Sent: Tuesday, 20 July 2021 5:21 PM
To: Kathryn Saunders
Cc: David Hoy
Subject: Nepean Gardens - comments on draft conditions and outstanding response items
Attachments: Draft Conditions - 20072021 - Urbis comments .docx; Nepean Gardens - Outstanding items - response July 2021 .pdf; Attachment B - Travers Tree Assessment.pdf; Attachment C - Axil architecture plans.pdf; Attachment A - Sewer diagram.pdf

A - Deferred commencement conditions

Re: Biodiversity Impact of Sewer – Wallacia Memorial Gardens

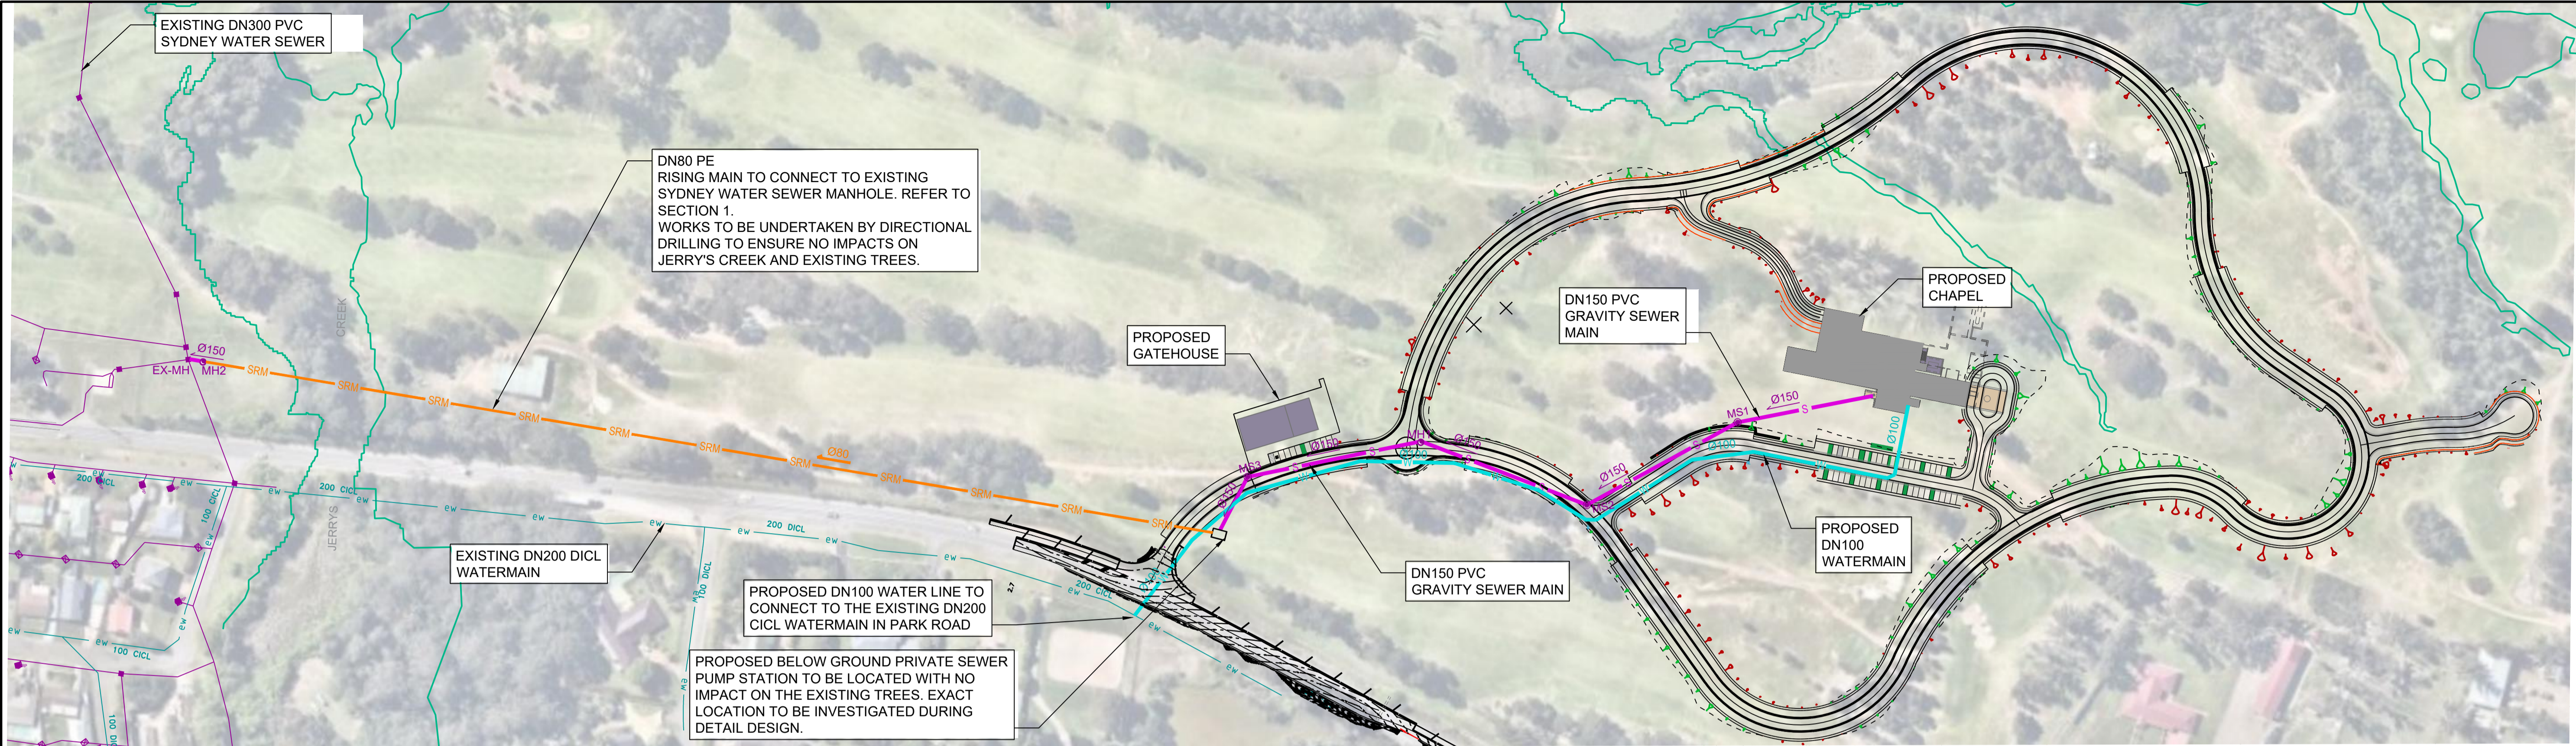
Eco Logical Australia Pty Ltd (ELA) has reviewed the attached proposed sewer pipeline for the Wallacia Memorial Gardens and confirms that the sewer pipeline would not require additional clearing of native vegetation.

The sewer line (marked in purple with 'S') and potable water line (marked blue with 'W') on the attached plan are within the proposed internal driveway/road alignment and therefore will not require any additional clearing beyond that required for construction of the road.

The sewer rising main (marked in orange with 'SRM') will be constructed using direction drilling which requires no surface disturbance other than at the entry and exist points, both of which are in areas already clear of vegetation. The depth of the directional drilling is no less than 1.775m below ground surface in the vicinity of Manhole 2, at least 2.63m below the level of Jerrys Creek and significantly greater depth for the remainder of the drilling.
